DAUPHIN COUNTY SUBDIVISION/LAND DEVELOPMENT REVIEW REPORT

Plat Title: Northern Dauphin Christian School Land Development

Project Description: Purpose of the plan is to propose a school building and athletic field. The plan also proposes access drives, parking, utilities and associated stormwater management facilities.

Easement Plan

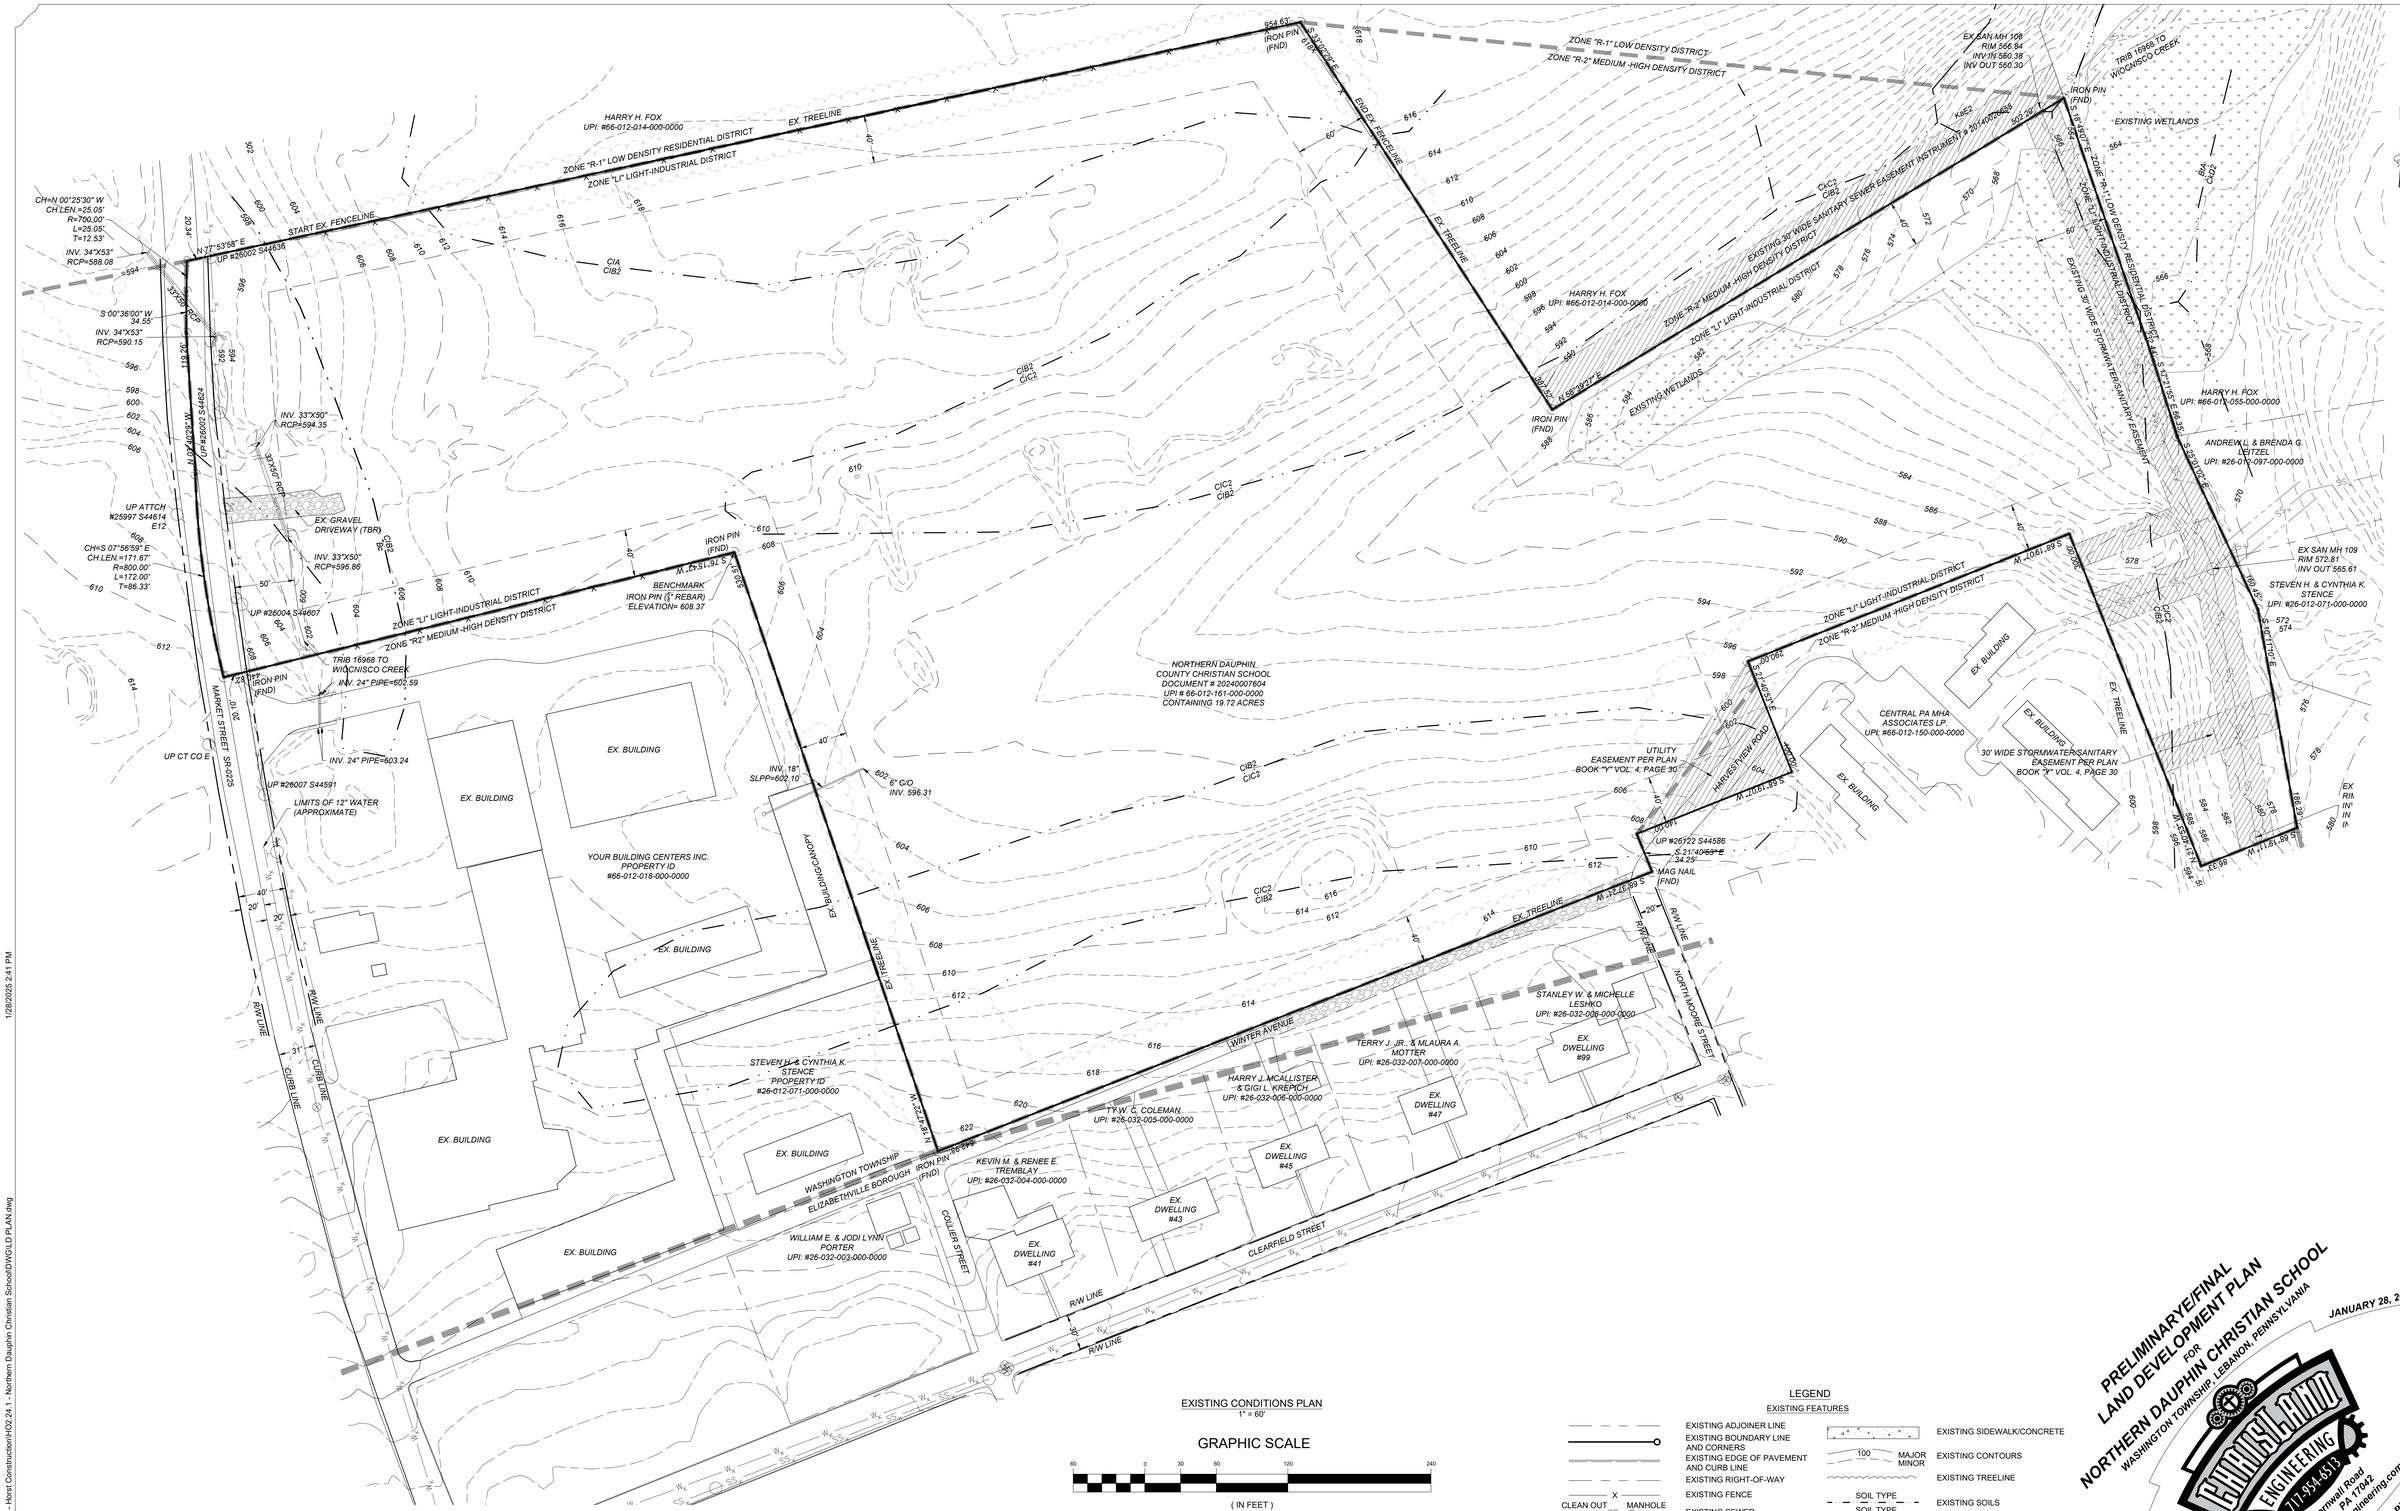
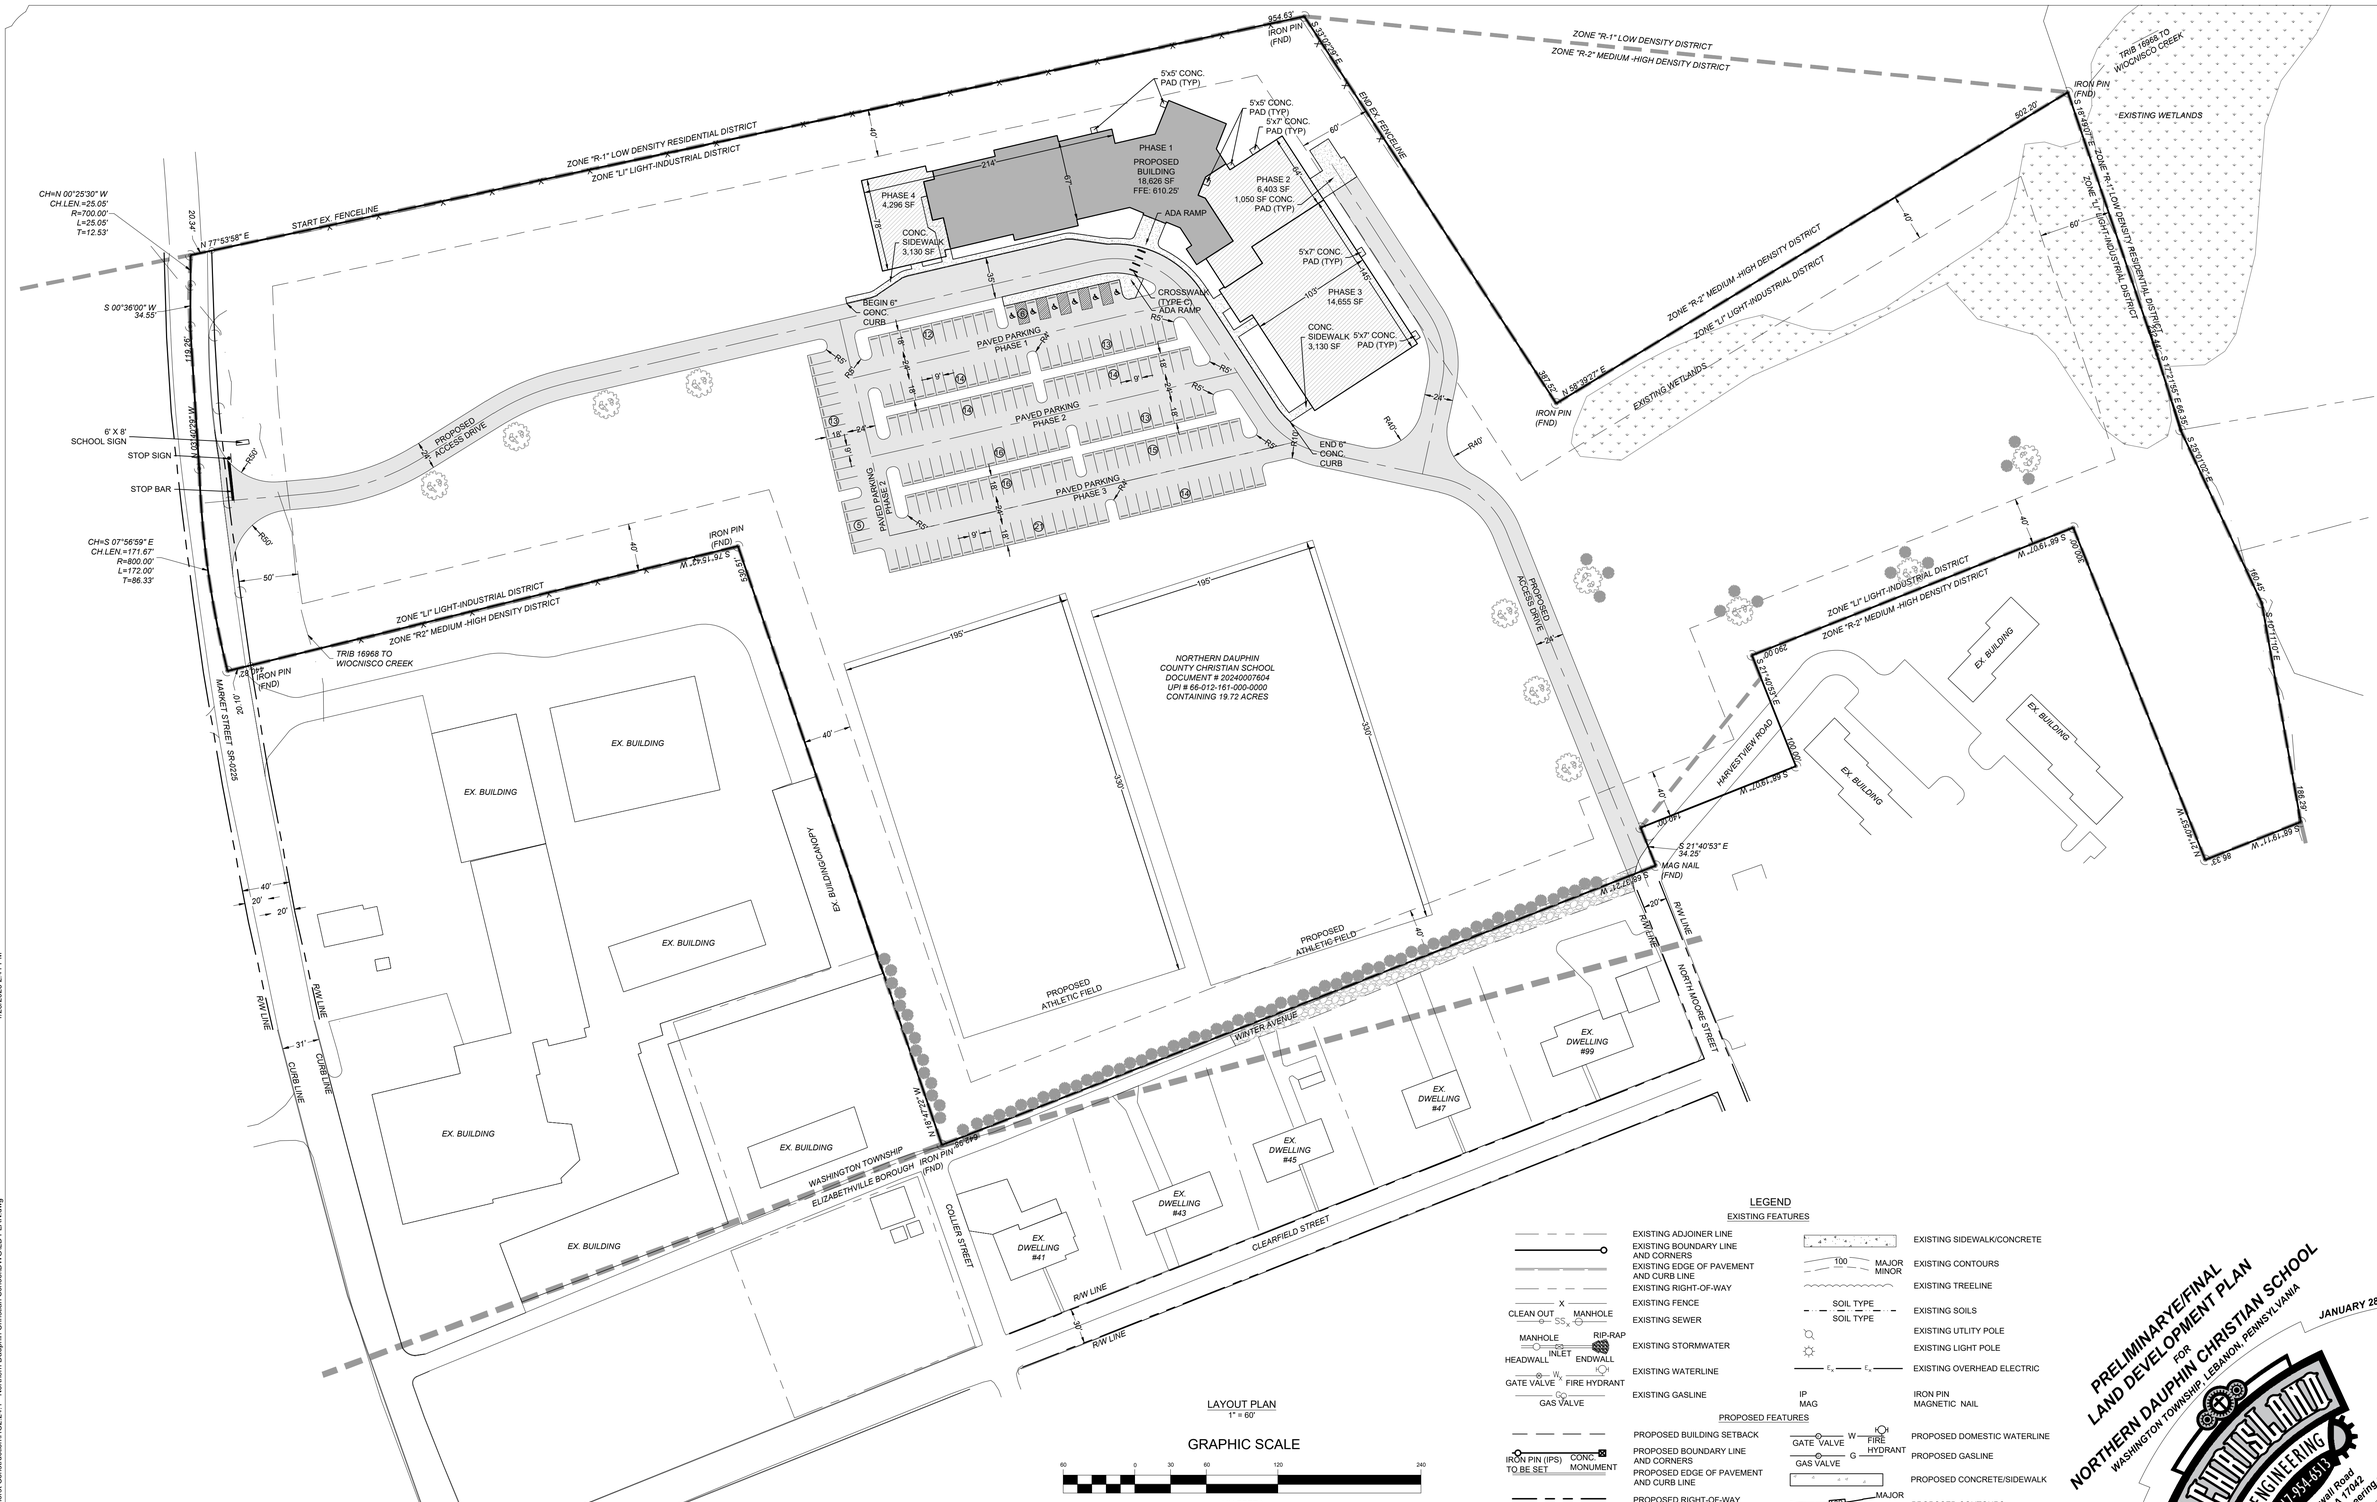
8) Harvest View Road infringes on the proposed development property. It is shown there is an easement in the area associated with the street, but it is identified as an "Utility Easement". It should be confirmed that this easement also allows vehicular traffic. It may be a prudent time to adjust such an easement if this is not in place.
